LADYJ Amendment Proposal

Analysis by the FAA regarding feasibility of adopting requested amendments to LADYJ Standard Instrument Departure.

Request to Move Route East at RUGBY

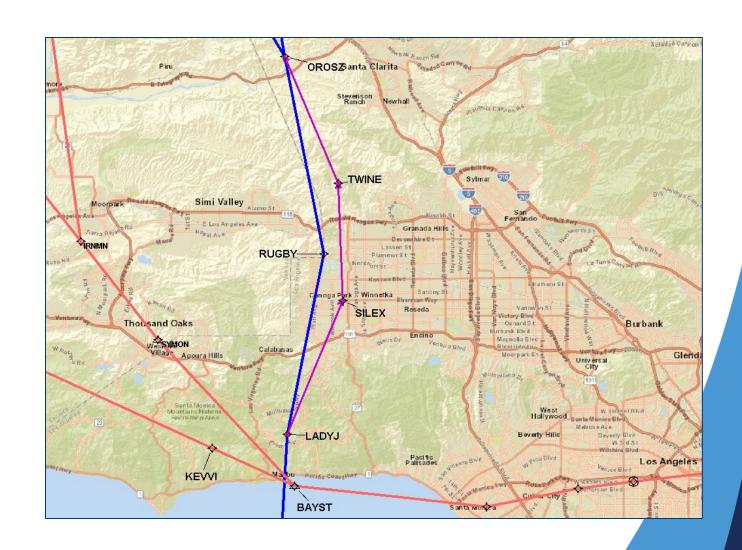
It was requested that the route between LADYJ and OROSZ be amended from over RUGBY to over SILEX and TWINE.

ATC advised that LADYJ SID design deconflicts LAX departures from BUR and VNY departures. Moving the LADYJ route to the east would create conflicts with that traffic.

The proposed routing would be less efficient and potentially less safe since the procedural separation would be removed resulting in increased controller workload.

Feasibility of amending the LADYJ SID

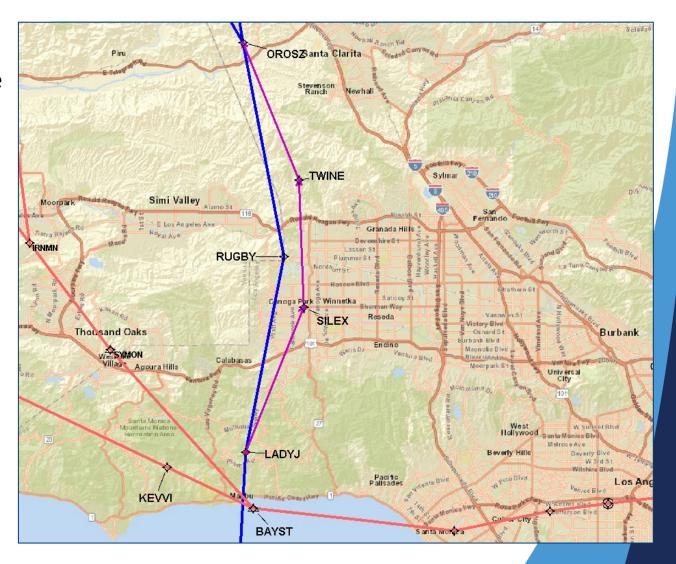
The proposed amendments were found to be operationally unfeasible by ATC. Therefore, the proposed amendments to the procedure will not be moving forward.
